# Access Compliance Report

## Public Rights-of-Way

### (Curb Ramps)

Intersection ID: 10027410	Main Street: GOLF_ACRES_DR	Cross Street: N/A	Location: NE
ADA ID: EFC99685C4D5	Ramp Type: PerpDiag	Initial Pass/Fail: Fail	Overall Compliance: No
		Severity Score: 25

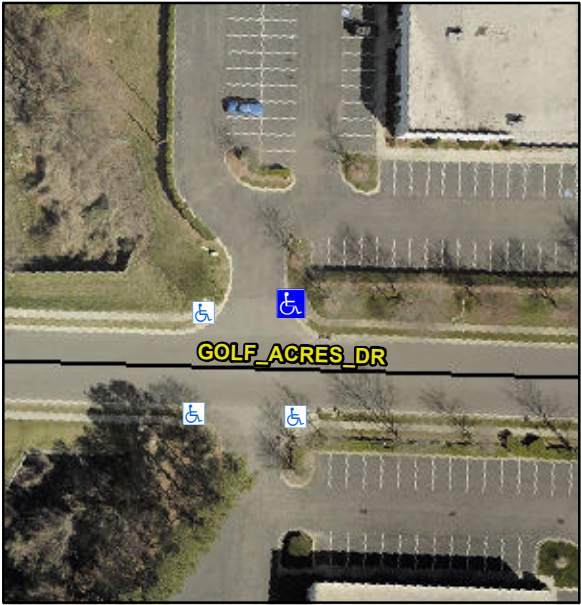
**Not Found, R304.5.3**

**Remove & Replace Curb Ramp With Two New Directional Ramps or Equivalent.**
